NON-MATERIAL AMENDMENT APPLICATION :- 14 Sunnydene Avenue, HA4 6AF

This application seeks consent for non-material amendments to the planning permission 26362/APP/2025/692. These proposed changes are as follows:

THE PROPOSAL: ELEVATIONS

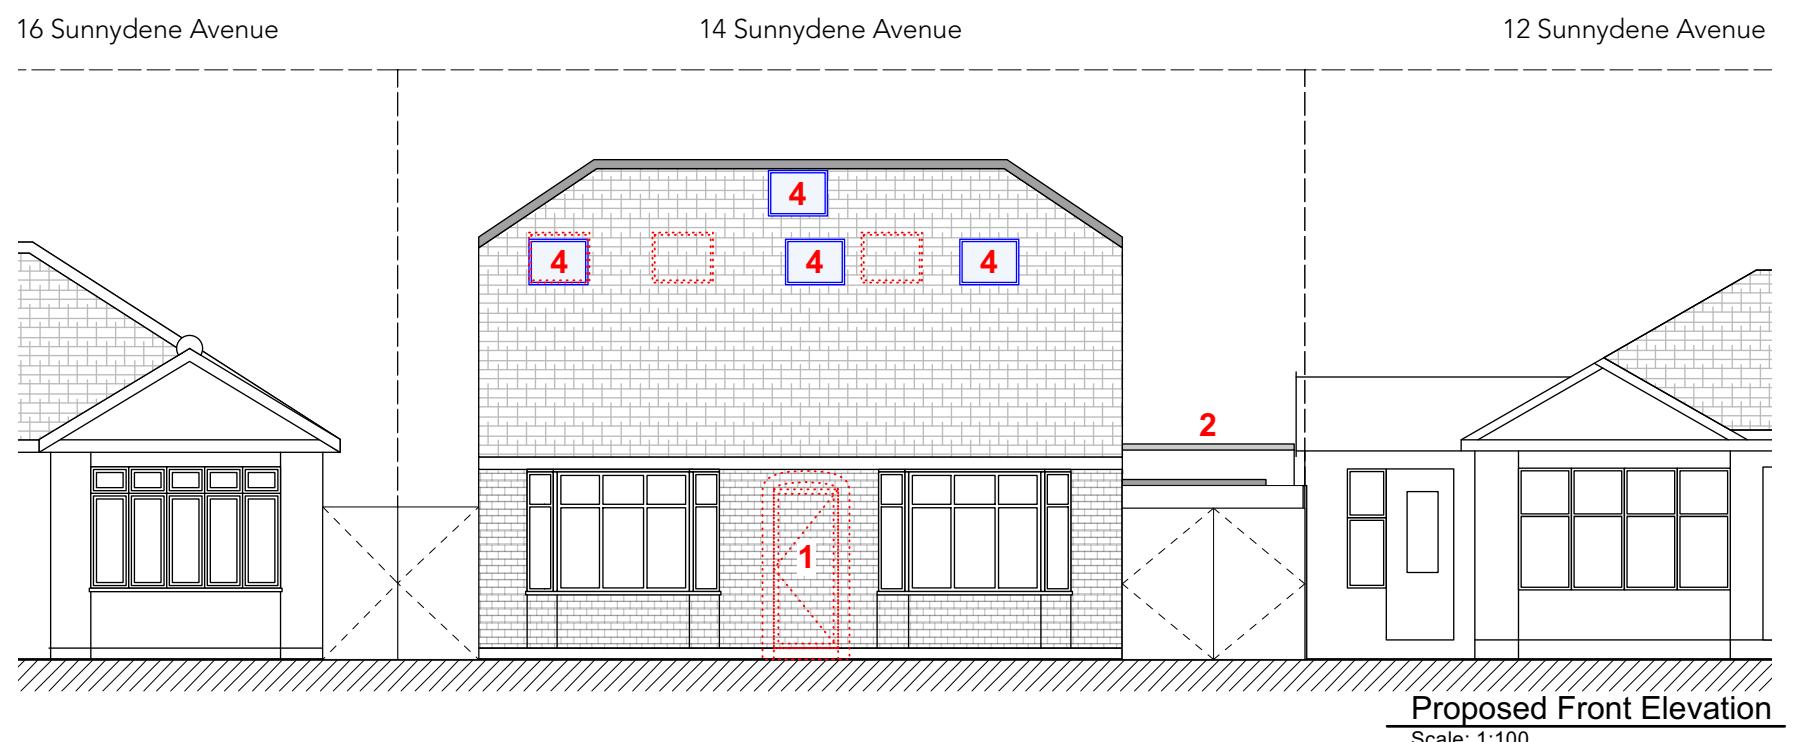
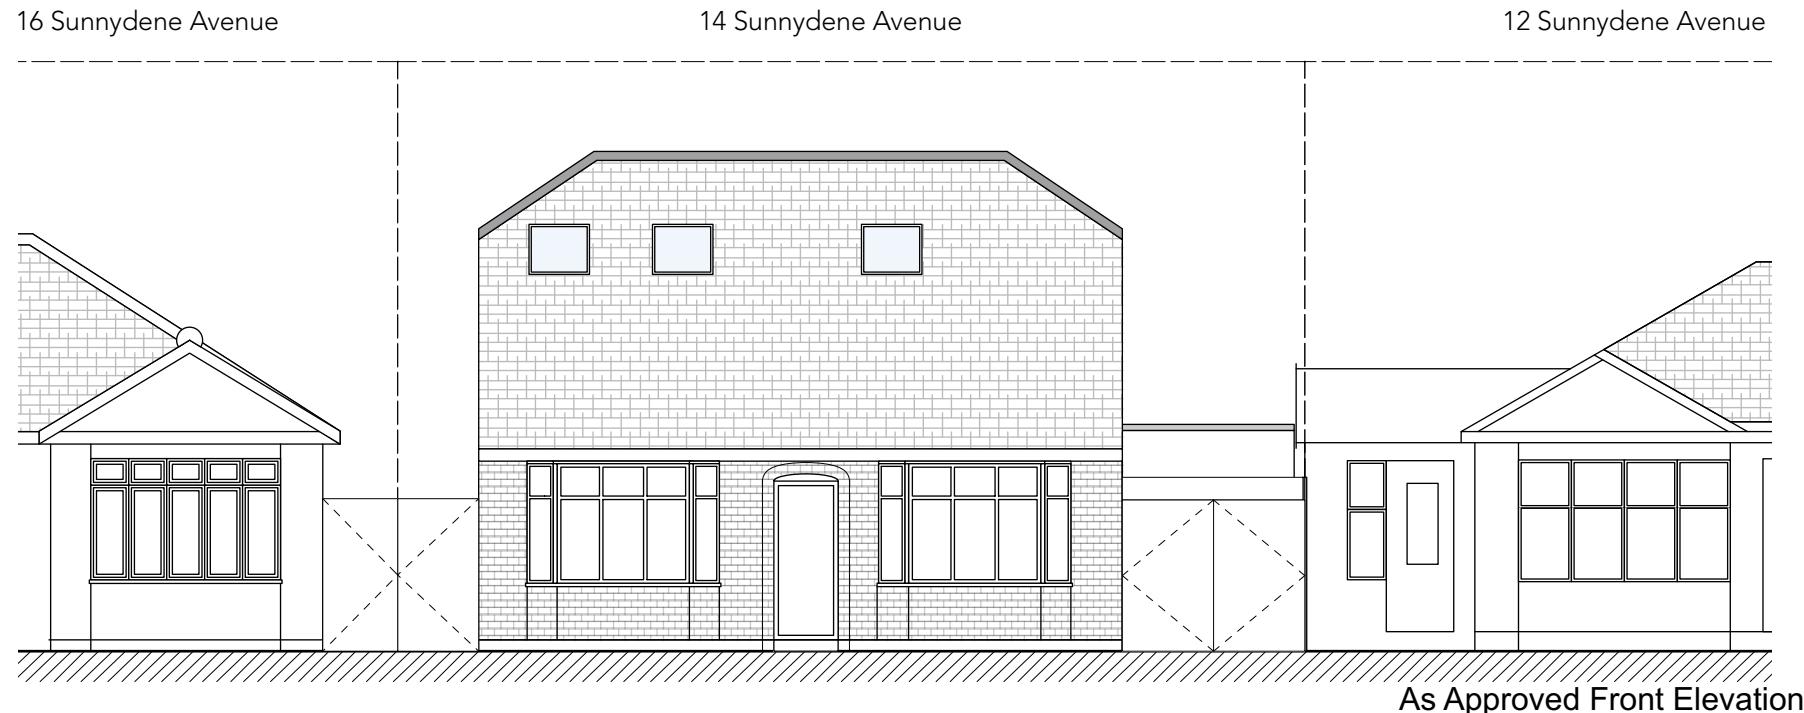
On the ground floor, the existing front entrance is bricked up and replaced by the side entrance. The proposed works will provide a better internal layout and more circulation space for residents.

As part of the changes on the ground floor, a utility is proposed replacing the wc, proposed with a side door finished in timber. The side door will provide access to the existing side passage. The door will not be glazed meaning no overlooking issues. x1 Proposed rooflight on the ground floor to the pantry will match the approved ground floor rooflights.

The proposal also seeks permission to amend rooflight locations on the first floor. The proposed rooflight spacing will provide no clashes with walls and are at an appropriate height for comfort. The rooflight approved on the rear roof slope has been moved to the front roof slope in line with the staircase location to provide natural light to this space.

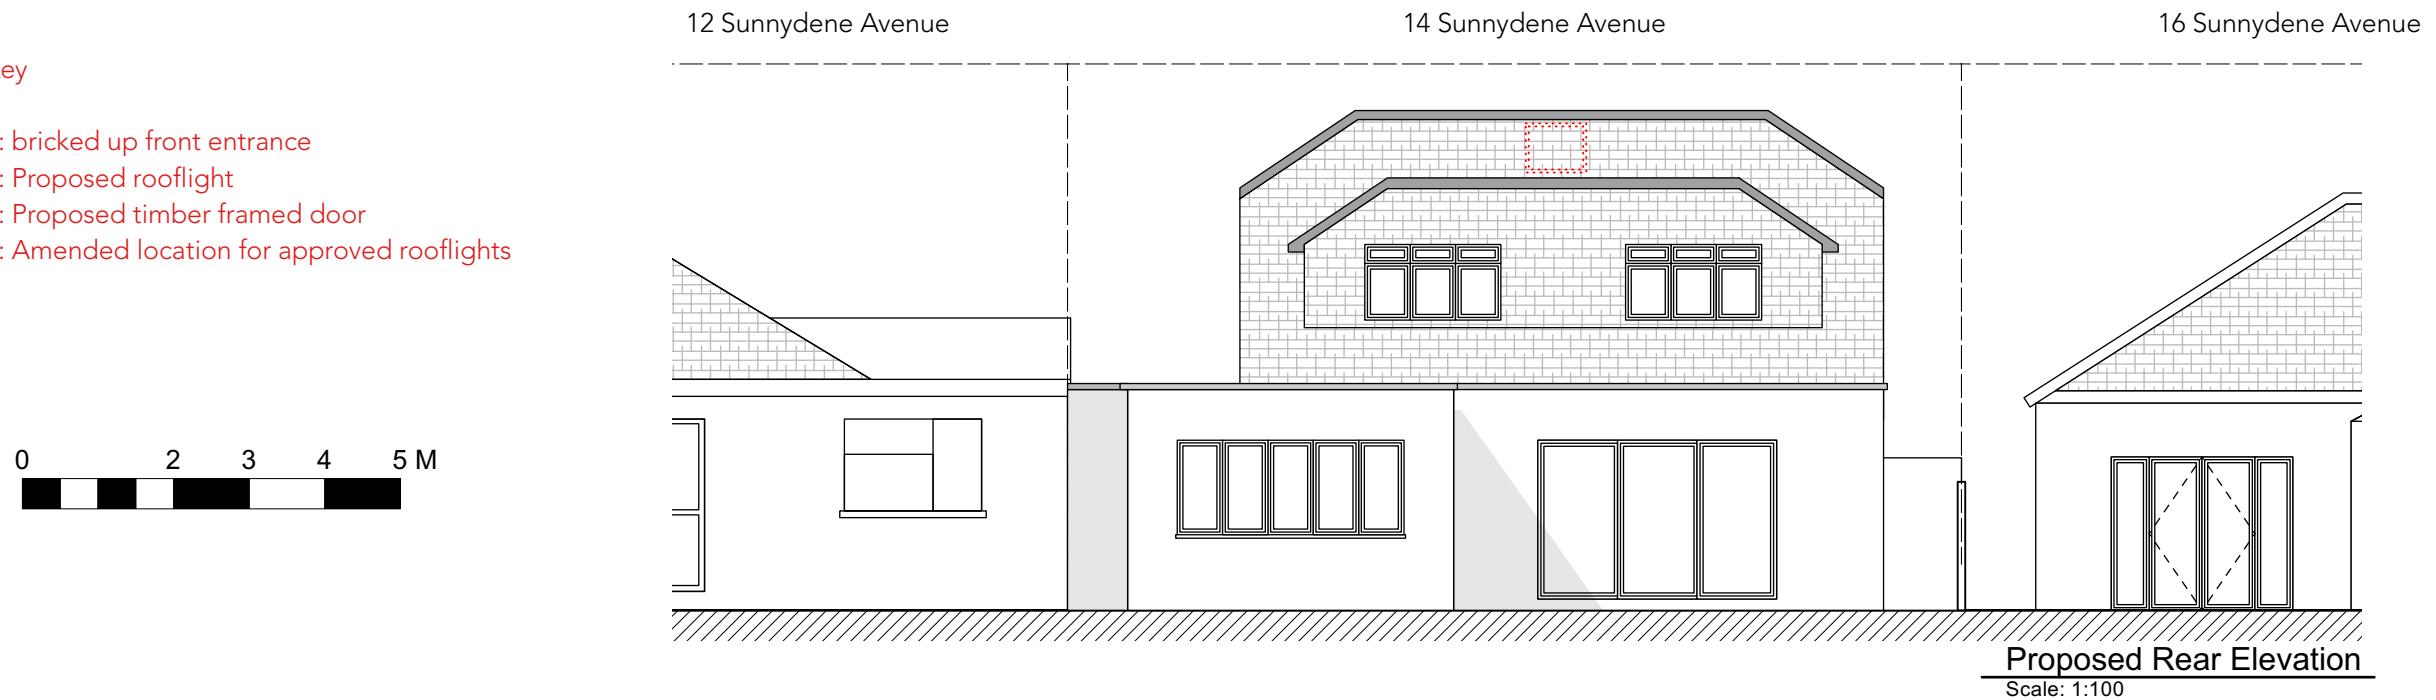
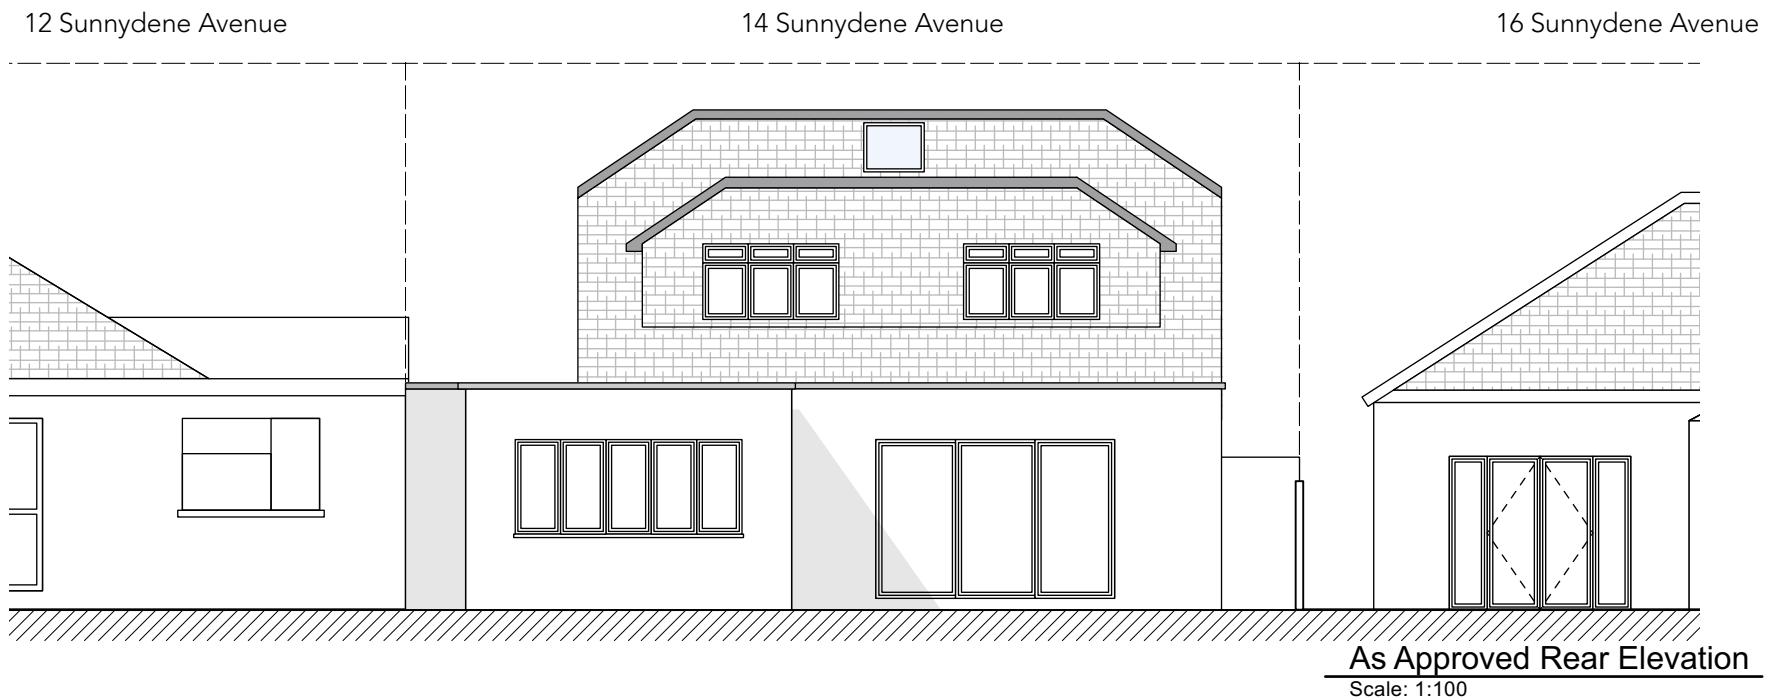
- 1: bricked up front entrance
- 2: Proposed rooflight
- 3: Proposed timber framed door
- 4: Amended location for approved rooflights

REAR ELEVATIONS: AS APPROVED AND PROPOSED

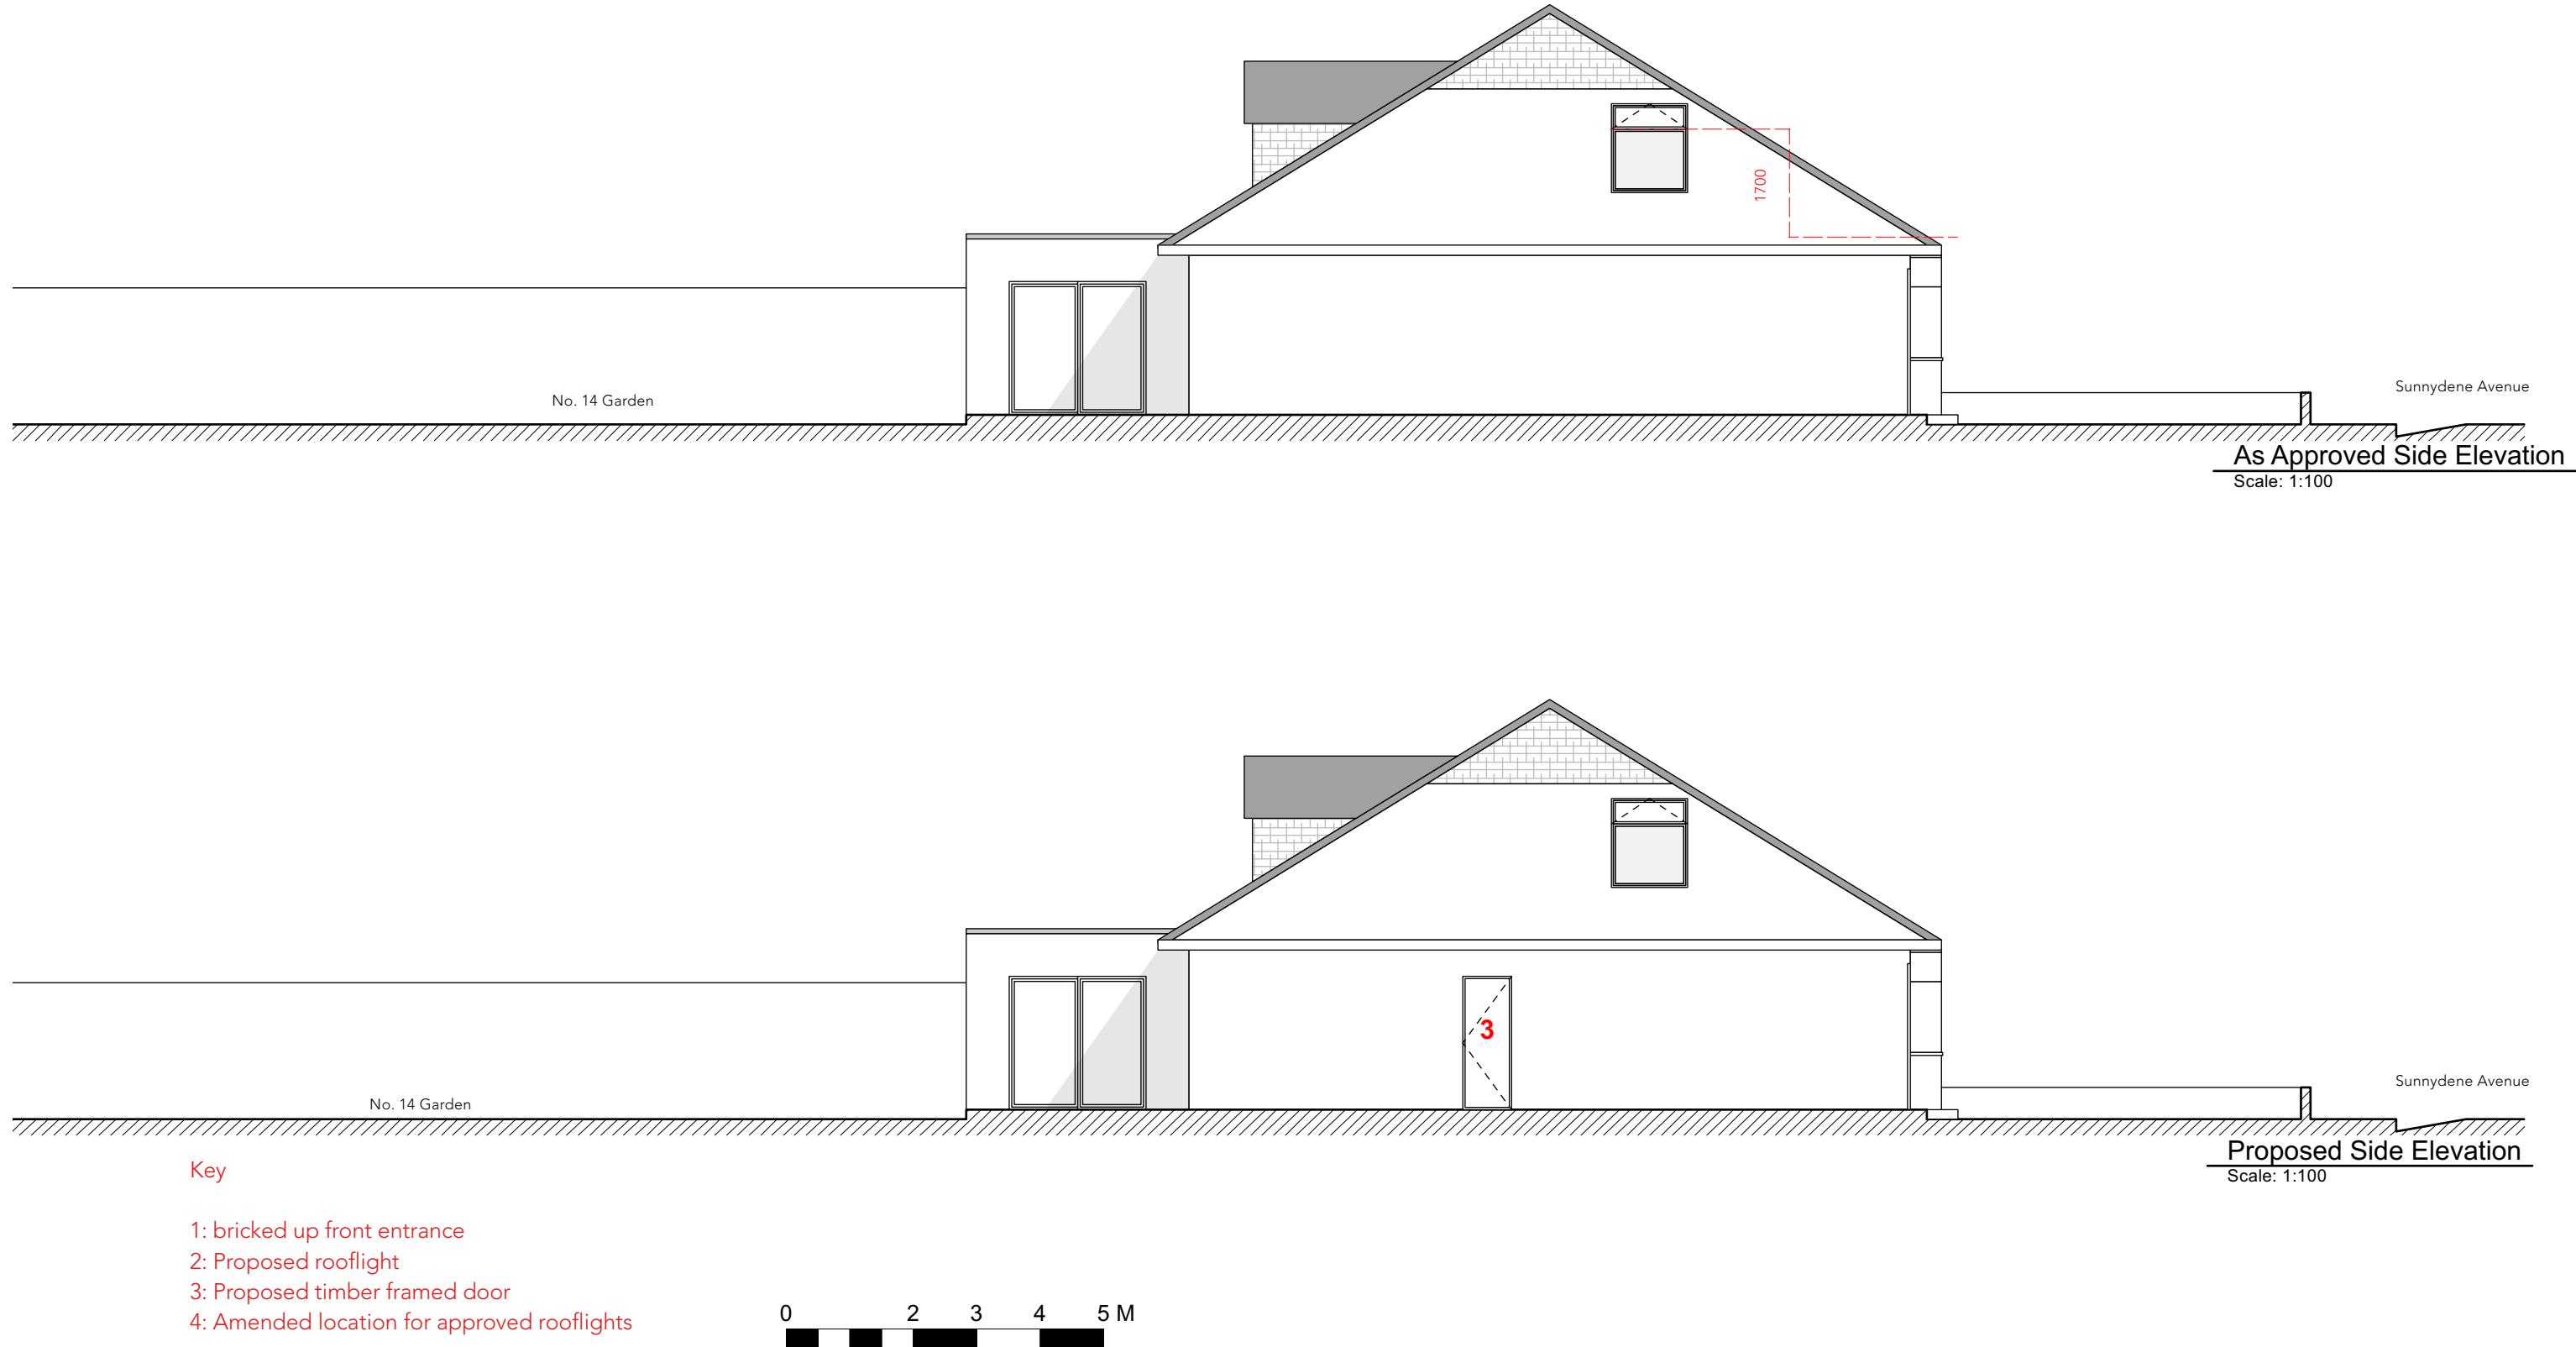
- + Front entrance bricked up
- + Timber framed door added to existing side entrance.
- + Proposed rooflight to ground floor pantry to match approved ground floor rooflights
- + Adjusting the location of first floor rooflights (x3) to the front roof slope. Rooflight to the rear roof slope (x1) to be relocated to the front roof slope
